SUBJECT: NORTH ANNA POWER STATION, UNIT 1 - ASME SECTION XI INSERVICE
INSPECTION (ISI) PROGRAM RELIEF REQUEST NDE-PARTIAL-2 (TAC NO.
MB1129)

The purpose of this letter is to grant you the relief you requested by NDE-Partial-2 for North Anna Power Station, Unit 1.

Sketch NDE-Partial-2-1
North Anna Unit 1
1-SI-TK-2
Weld 1

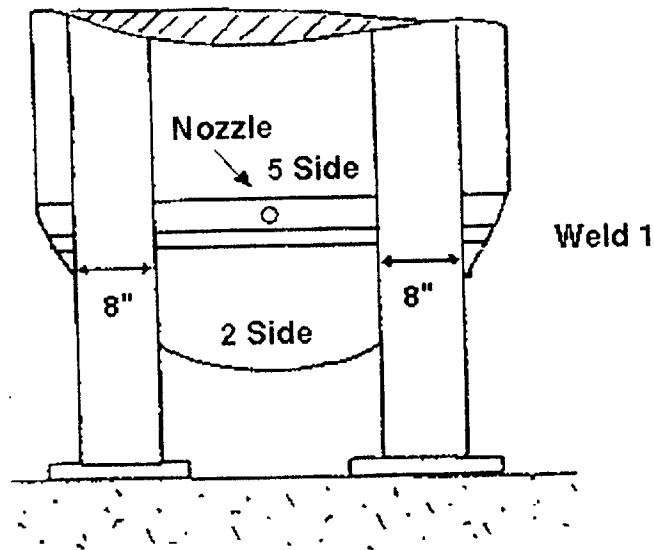
Table NDE-Partial-2-2
North Anna Unit 1
Examination Scan Coverage Estimates (Boron Injection Tank)
Weld 1

Beam Angle (degrees)	Exam Area	Scan Direction	Scan %
0	Base and Weld	0	82
45 and 60	Base	2	96
45 and 60	Base	5	97
45	Weld	2	58
45	Weld	5	76
45	Weld	7 & 8	77
60	Weld	2	61
60	Weld	5	76
60	Weld	7 & 8	77
			Avg. 78

Sketch NDE-Partial-2-2
North Anna Unit 1
14"-RH-2-602-Q2
Weld 72H

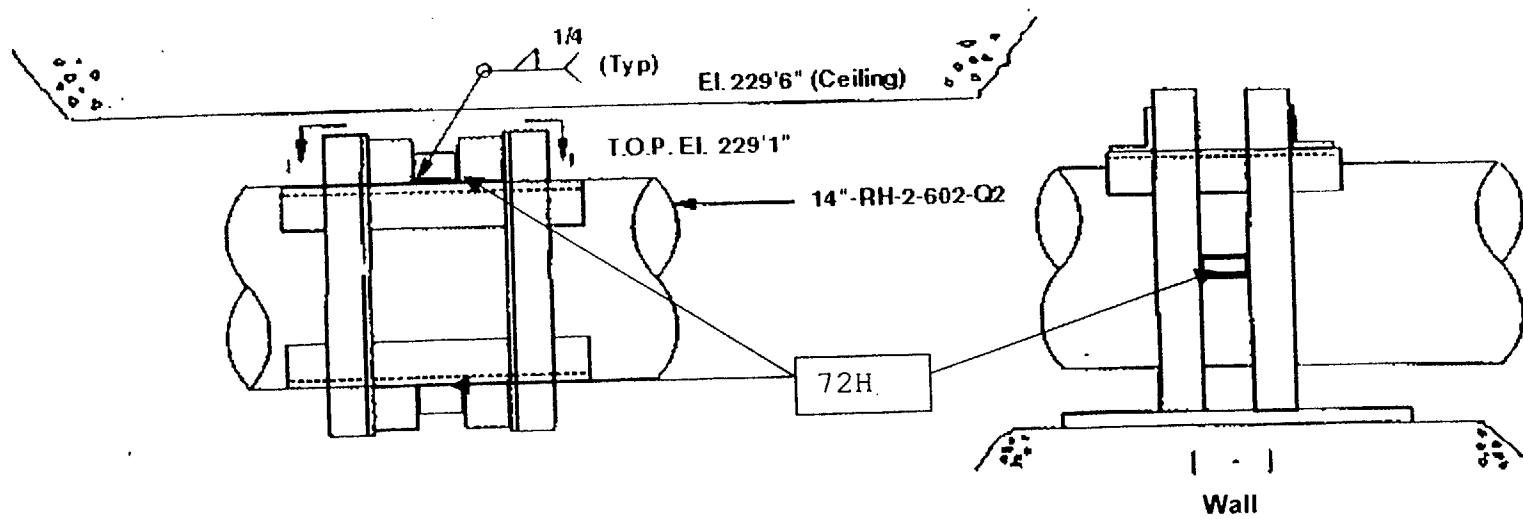
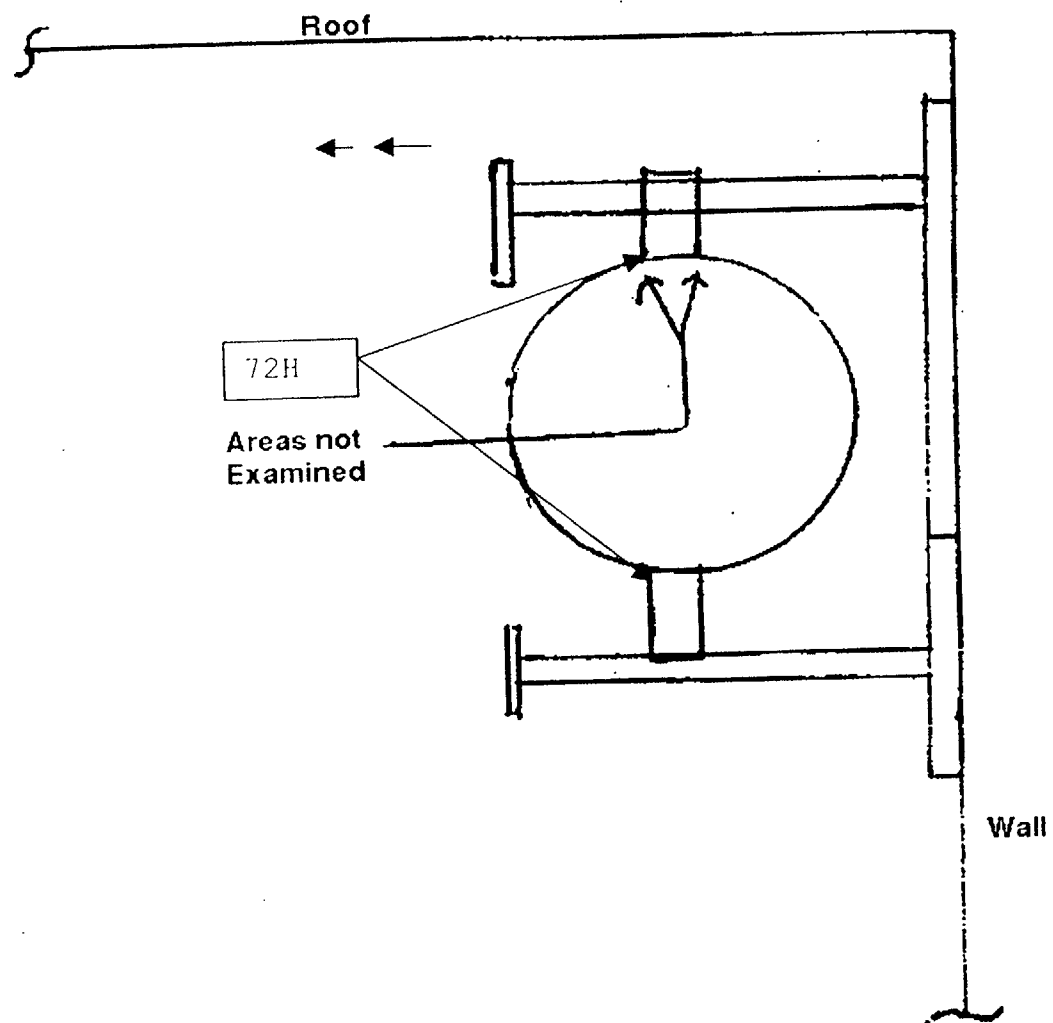
Top Lug of Integral Attachment is
Inaccessible for PT Examination

Sketch NDE-Partial-2-4
North Anna Unit 1
1-CH-P-1A
WS-03 and WS-04

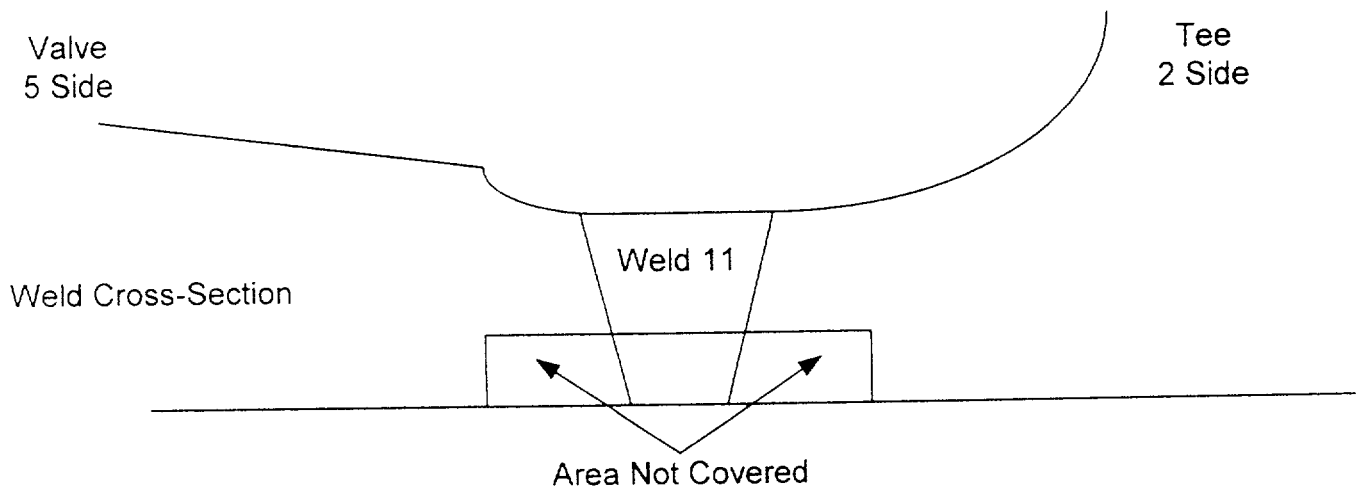
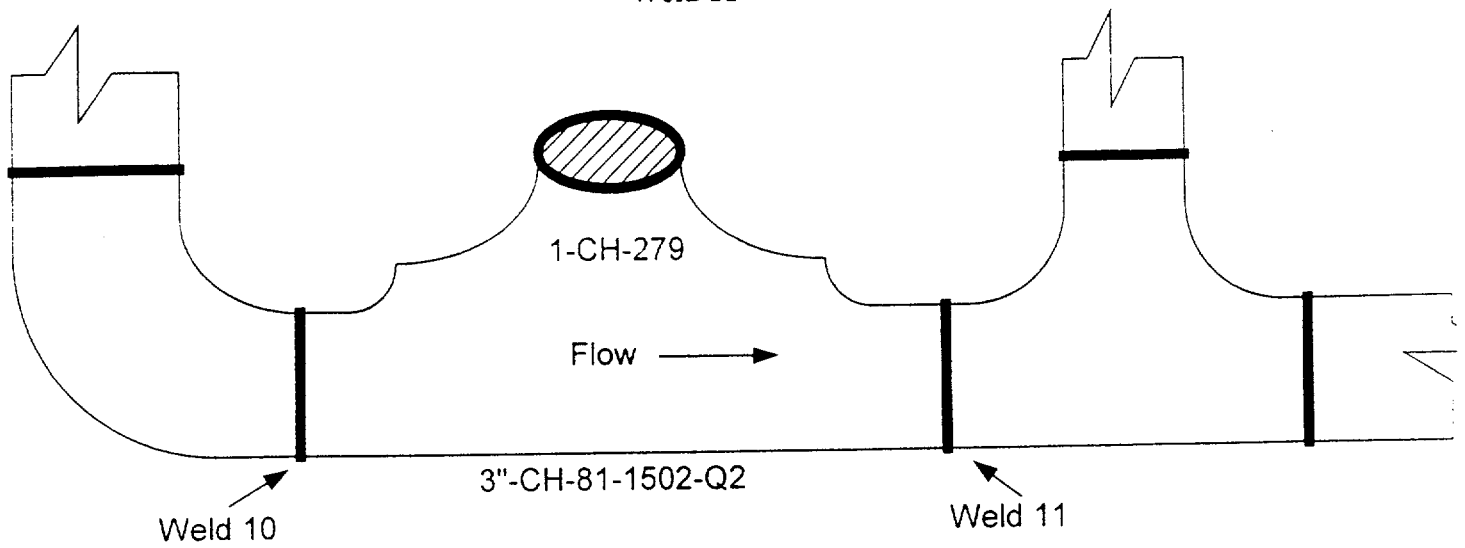
Inaccessible Area is the area
inside the box
